13/14-04A 22900 Whelan Lane

MP Site 13/14 Moneysworth Farm

**MEMORANDUM**

SUBJECT: Historic Area Work Permit

# Figure 1

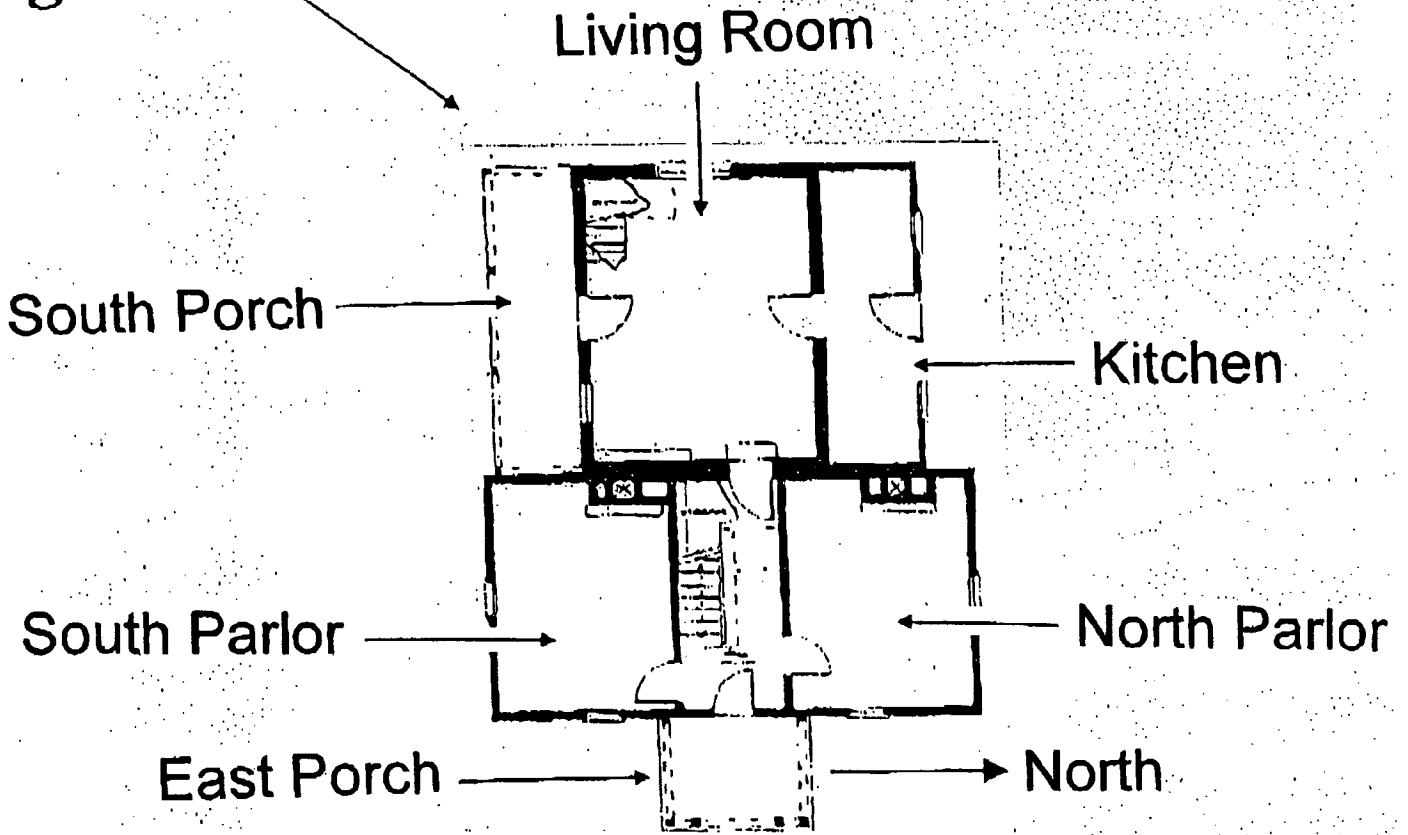
1. The primary entrance where the east porch is connected to the house is in very bad condition. The floor and foundation of the porch are in need of repair. The columns that support the roof of the porch are not all standing. See Figure 1.

1. The first room that was inspected was the north parlor. See Figure 1. The floor is not stable. The floor system below the planking has been compromised in some way and there needs to be further investigation. The floor planking was removed along the front wall.

4. The floor and roof of the south porch are also in very bad condition. The roof cannot be salvaged. See Figure 1.

5. The kitchen has major structural issues. This appears to be the area of the house with the largest problem including decay of the wood members and termite infestation. The ceiling is falling and the roof system is damaged. The floor planking was removed in this area. The floor members observed has major deterioration. See Figure 1.

1. The east porch, which is the primary entrance, needs to be replaced. A new foundation needs to be repoured and the whole floor needs to be replaced. The columns must either be restored or placed to match that of the original house. See Figure 1.
2. The siding at the right side (north, facing the detention facility) of the house which is decaying needs to be removed and there needs to be more inspection as to the condition of the stud walls. Some replacement of the stud walls will most likely be required.

1. The entire floor system of the north parlor must be replaced. Some of the floor planking might be salvageable, but indications are that major restoration will be needed. The sill plates in this area must be checked. It appears that at least 50% of them will have to be replaced. See Figure 1.

3. The whole roof and floor system in the south porch area (area facing the chicken coop) needs to be replaced. Major damage was observed throughout this area. See Figure 1.

4. The kitchen ceiling has major deterioration. The ceiling and floor plank have been removed in order to review the floor and roof system. From the observations we were able to make the entire floor and roof system must be removed and replaced. The walls are also decayed to a point where they must be removed and replaced. See Figure 1.

5. The living room has problems with the floor and walls. The plaster walls are falling down in some areas and might need to be replaced. When these walls are being fixed, the wall studs should be inspected in order to determine the condition. The floor needs attention in that the coverings mentioned in the observations needs to be removed as soon as possible to allow the wood planking to dry. All of the coverings were removed so we could make proper observations. The floor system, even though they were uneven, appeared to be structurally sound. See Figure 1.

# Figure 2

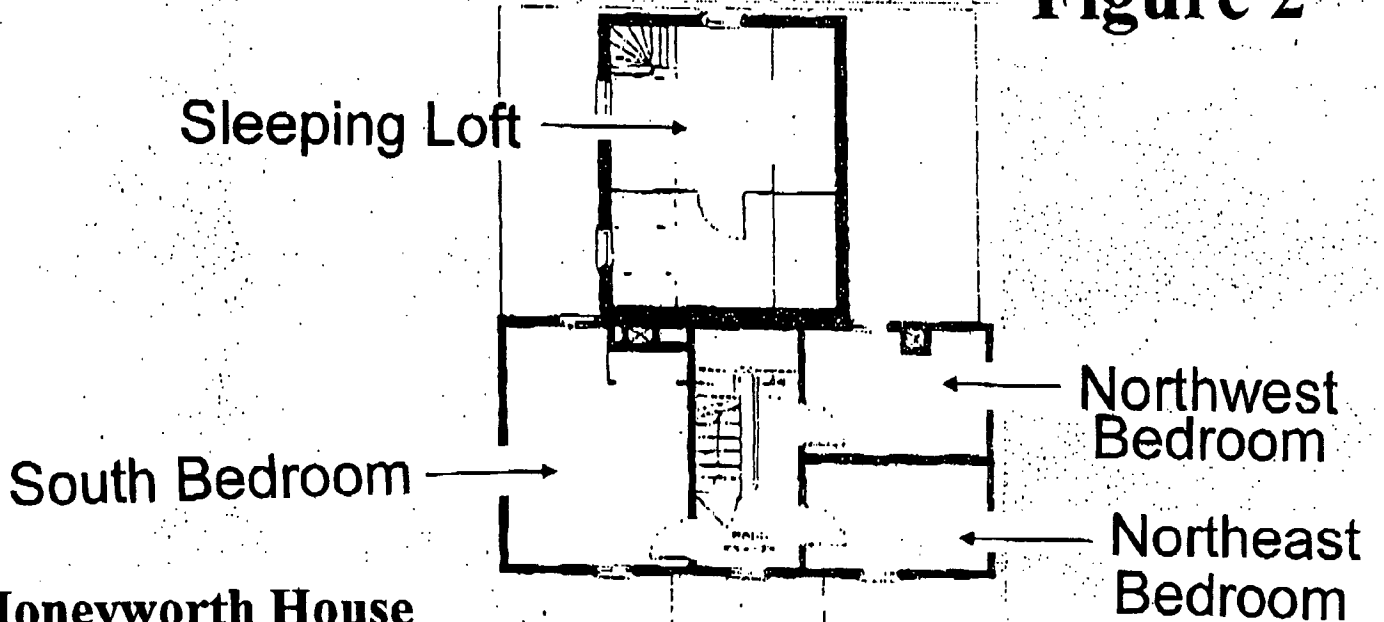
7. The second story over the living room in the center of the house is in satisfactory condition. The floor is not completely stable but the walls and ceiling are intact. The stairs up to the second floor need to be reinforced to minimize the amount of deflection when using them. See Figure 2.

8. The second story of the house that is accessible near the front door appears to be structurally sound. The stairway appears to be in good condition. Some of the floors of the second story rooms need to be checked because of the deflection that occurs by just walking on the floor planks. The walls and ceilings for this part of the house are intact. See Figure 2.

6. The sleeping loft and bedroom directly over the living room needs to be improved. The floor appears to be unstable and therefore we recommend that several exploratory holes be made to verify the condition of the floor members. The walls and ceilings appear to be in good condition in this room. See Figure 2.
